Project	IEEE 802.16 Broadband Wireless Access Working Group < http://ieee802.org/16 >	
Title	Examination of proposed interference resolution techniques and messaging for IEEE 802.16h & additions to working document 802.16h-05_022	
Date Submitted	2005-11-10	
Source(s)	John Sydor, Shanzeng Guo Communication Research Center 3701 Carling Ave Ottawa, ON, Canada, K8H 8S2	Voice: (613) 998-2388 Fax: (613) 998-4077 { jsydor , sguo }@ crc.ca
Re:	Call for Contribution, "IEEE 802.16's License-Exempt (LE) Task Group", 2005-10-17 Item 4.	
Abstract	This document contains additions to the draft IEEE802.16h working document and raises some questions about the efficiency of currently proposed approaches to interference resolution as outlined in the subject working draft document. The sections and paragraphs given below refer to those of the subject working draft document IEEE802.16h-05/022. All direct additions to the working document are given in italic font and included below

Examination of proposed interference resolution techniques and messaging for IEEE 802.16h & additions to working document 802.16h-05_022

John Sydor, Shanzeng Guo

Figure 1 Discovery Process

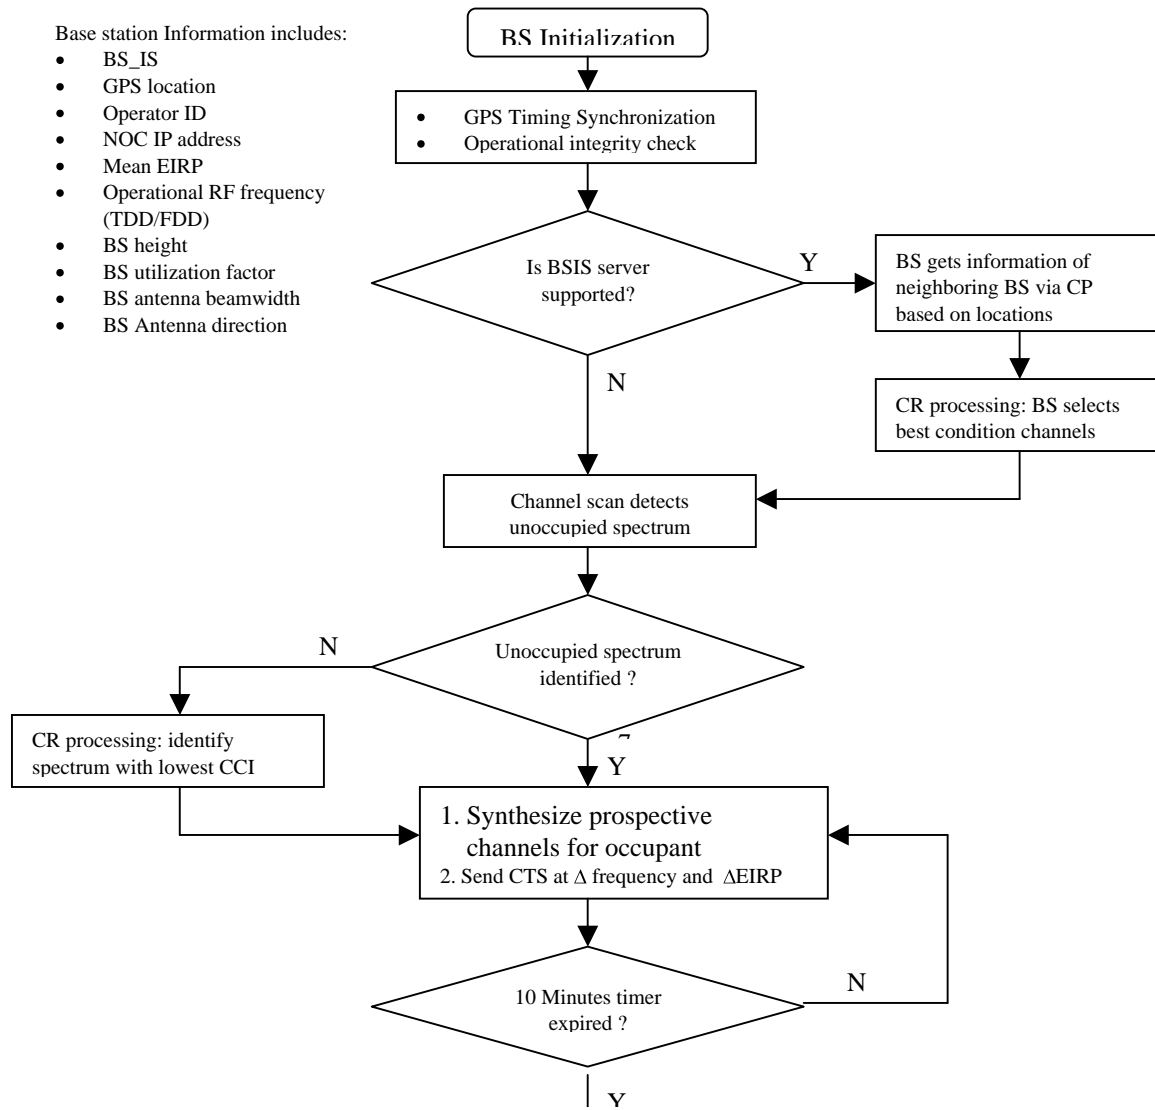
This section describes the entry process of a new network into a community of established networks on a non-interfering basis. As detailed in the discussion above (Sec 15.2.1.1.3), the current approach relying on CTS cannot guarantee an interference-free community of networks. The reliance on a centralized database to contain global information about the community is also questioned and addressed in the comments given below (15.2.2.1). As an extension to these comments and the proposed changes to the current working document IEEE802.16h-05/022 that have been addressed in IEEE S802.16h-05/038 and IEEE C802.16h-05/039, an addition is proposed for Section 15.2.1.3 which is outlined below.

The network entry process is as detailed in Figure 1.

A newly entering BS, prior to establishing a network will undertake the following entry steps as shown in Figure 1.

- *On initialization, the Base Station will derive a GPS 1pps timing reference and the UTC time stamp.*
- *The BS will determine its GPS location.*
- *The BS will then check to see if it has the IP address of a remote database that will allow network discovery of other BS.*

- *IF an BSIS server or IP data base address exists, the BS will determine the GPS locations and IP addresses of all potentially interfered with stations. If no BSIS or database IP address exists, potentially interfered-with station are not known, but still can be present.*

- *The BS then undertakes a spectrum scanning process, searching over its intended coverage for zones of no occupancy. If occupancy exists, it will be graded by the CR processor associated with the base station. If all spectrum is empty, proceed to sending of CTS.*

- *CTS messages are sent at every opportunity for 10 minutes*
- *Responses in the form of BS_CCID_IND and SS_CCID_IND messages are received at the initializing BS and used for the coexistence protocol. If no responses are provided the initializing BS proceeds with registration of its IP address and GPS location with the “Radius” server or equivalent.*

Figure 2 Entry Negotiation Process

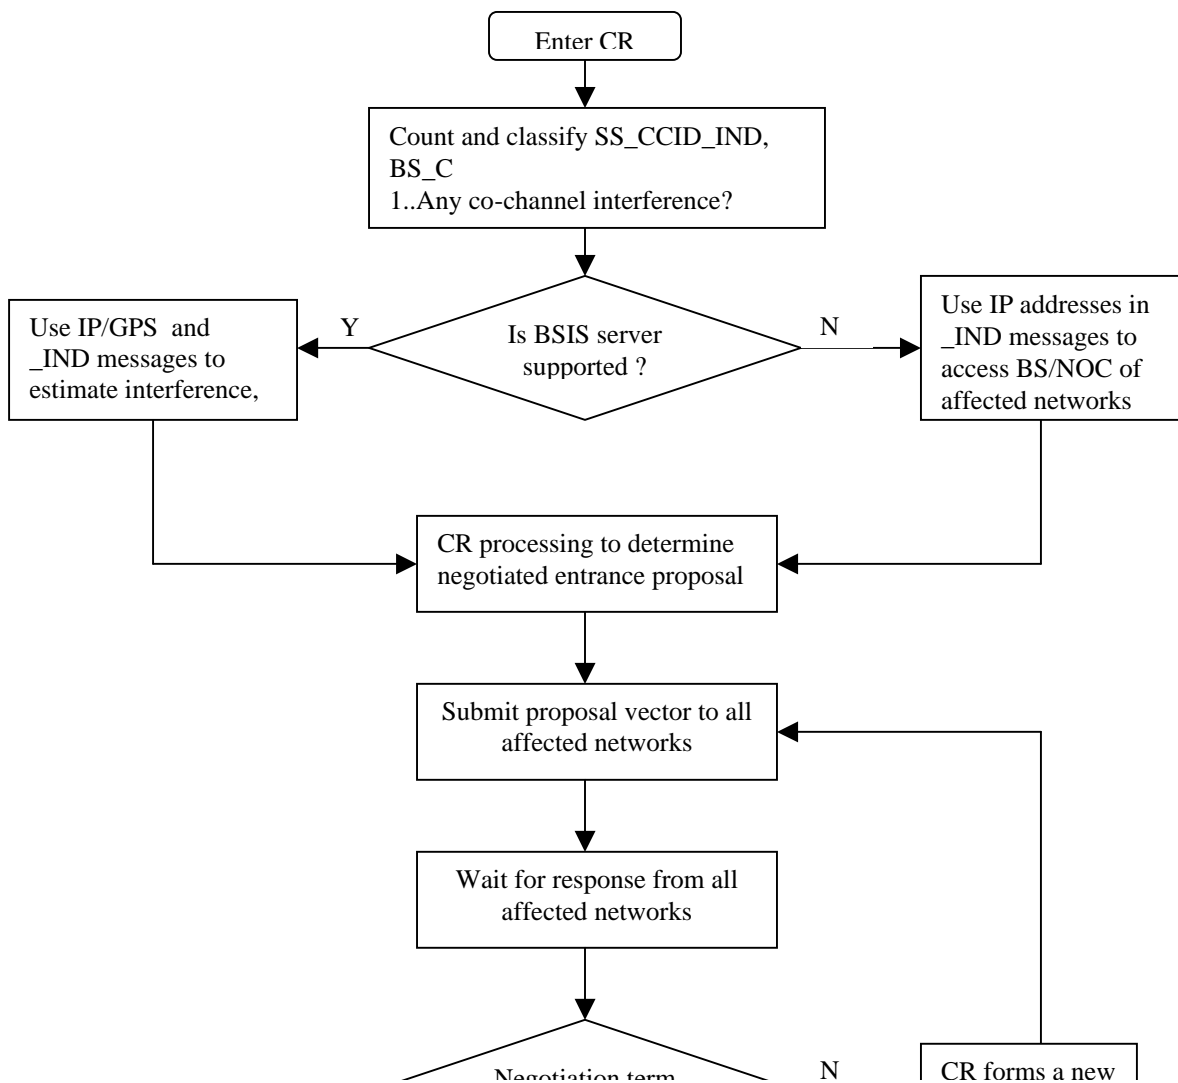
The CR negotiation protocol is shown in Figure 2. The salient features of the protocol are:

- After the CTS discovery the *_IND* messages are counted and correlated with IP data/GPS location data of proximate BS. The Cognitive Processor at the initializing BS or the BS_NOC categorizes interference instances, conducts analysis for hidden nodes (ie, for networks which are proximate, but gave no responses) etc.

- The initializing CTS, having identified the community or proximate networks that it seeks coexistence with, communicates with the base stations (or their CR_NOCs) and initiates a process of information exchange in which the contacted networks provide the initializing network with details on their operation. This process will likely require some form of private key exchange to transport sensitive information.

- Information received by the initializing BS (BS_NOC) is then used to create a “negotiation vector”, which is really a submission, or series of submissions to the base stations with which coexistence is sought. The transaction occurs at the TCP/IP layers. The operating BS examine the effects of the “negotiation vector”

- Operating BS either accept the proposal or reject it. The process is undertaken until a coexistence scheme can be rationalized whereby space, time, and coverage area are negotiated for use in manner favorable to all networks. Once agreement is reached, operating and initializing BS configure their operation for the new ad-hoc topology and community.
